UNITED STATES PATENT AND TRADEMARK OFFICE

Office Action Summary

09/836,351

DETAILED ACTION

FIG. 11

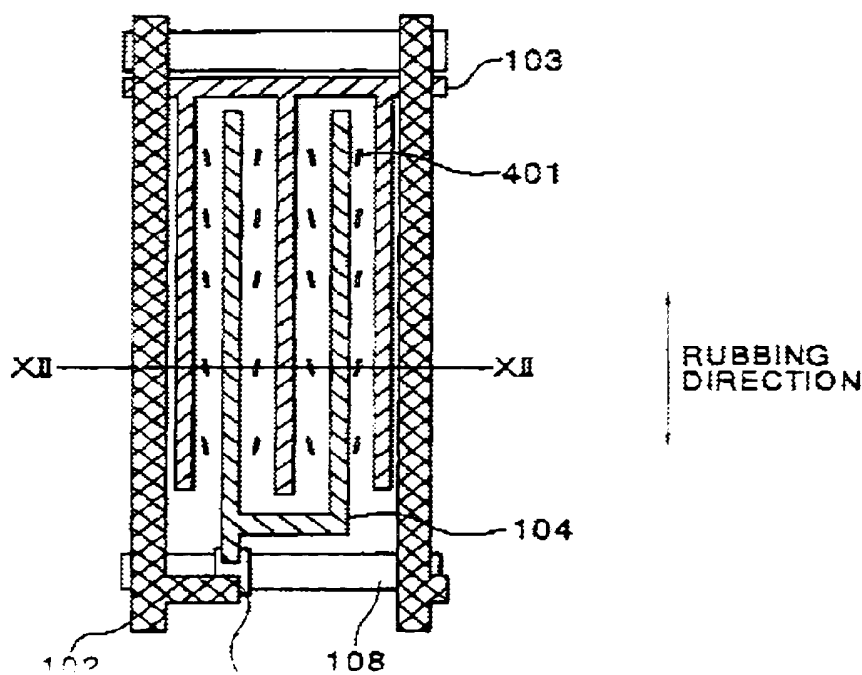
As to claim 1, Watanabe discloses in the first embodiment (col. 5, line 51 through col. 8, line 5 and Figures 11, 12, and 16), an IPS-LCD device, comprising: first, 101, and second, 201, substrates opposing each other; a scanning (Applicant's gate) line, 108, on the first substrate; a signal (Applicant's data) line, 102, perpendicular to the gate line; a thin film transistor, 109, at a crossing portion between the gate and data lines; a common electrode (portion running left to right in Figure 11 Applicant's common line)

bottom in Figure 11), 103, electrically connected to the common line, wherein the common electrodes are spaced apart from each other; a plurality of pixel electrodes, 104, alternately arranged with the plurality of common electrodes, wherein each pixel electrode is spaced apart from an adjacent common electrode; a plurality of insulator films (Applicant's dielectric protrusions), 105 and 106, between the first and second substrates; and a liquid crystal layer, 301, between the first and second substrates, wherein the liquid crystal layer and the dielectric protrusion have different dielectric constants as evidenced by Figure 16 and Table 2 (col. 7, lines 31-42).

FIG. 16

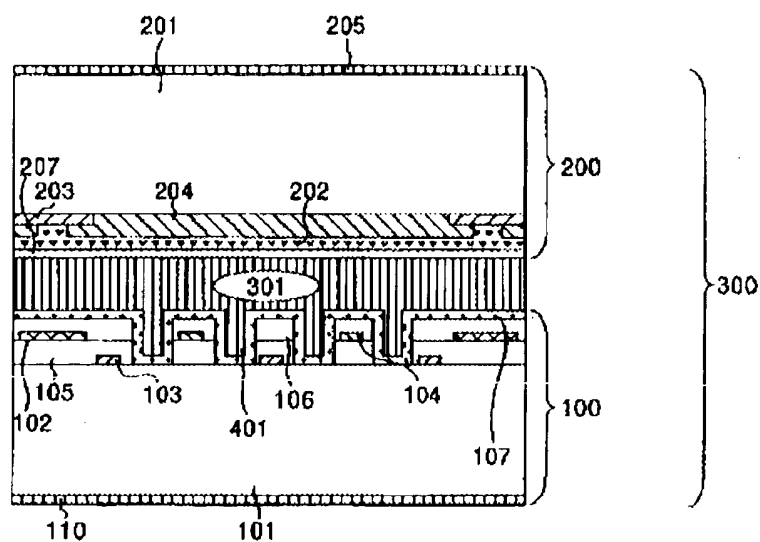
As to claim 2, Watanabe discloses the dielectric protrusion has a smaller dielectric constant than the liquid crystal layer in Table 2 (smaller than major axis, col. 7, lines 31-42).

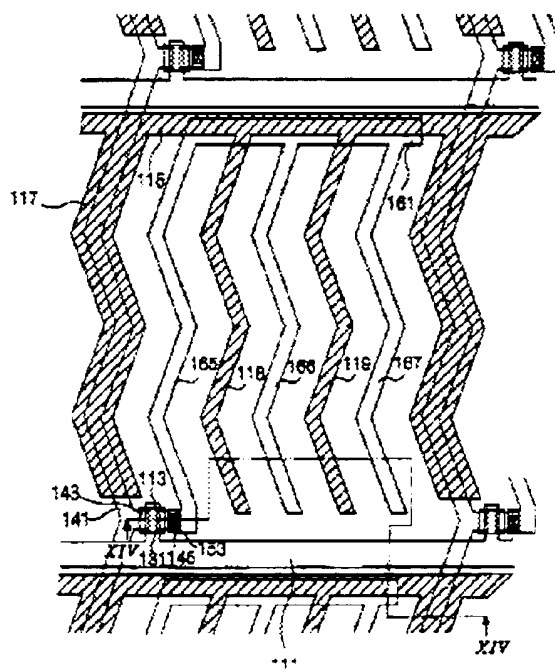
Wantanabe does not explicitly disclose pixel electrodes of ITO or ZTO, and Wantanabe does not explicitly disclose a common electrode of Cr, Al, Mo, Ta, W, Sb or alloys thereof.

Kawano teaches the use of AI for pixel electrodes and opposite electrodes (Applicant's common electrodes) (col. 15, lines 38-44) in an in-plane switched (IPS) LCD that may optionally be made of ITO.

FIG.2

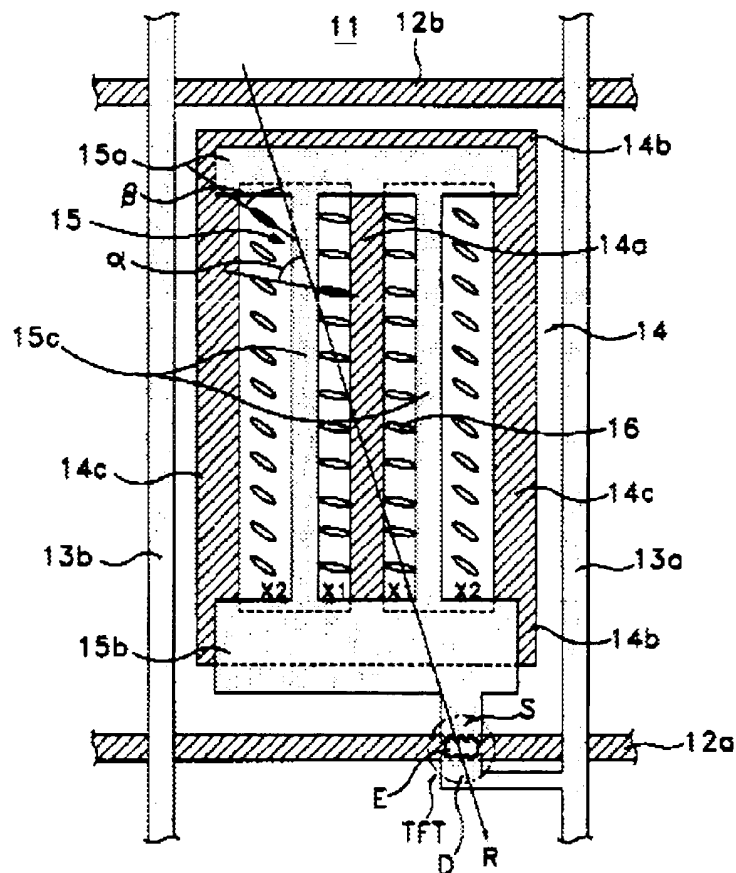
Lee teaches in Figure 2 an IPS LCD with negative or positive dielectric anisotropy (col. 2, lines 25-26), and Lee teaches the rubbing direction is changed to be compatible with the anisotropic characteristics of the liquid crystal material (col. 3, lines 47-65) to achieve proper switching of the liquid crystal material. Note that some of the angles are improperly expressed, however, one of ordinary skill in the art of liquid crystals would understand that the LC molecules of negative dielectric anisotropy are aligned substantially perpendicular to the electrodes in the off state.
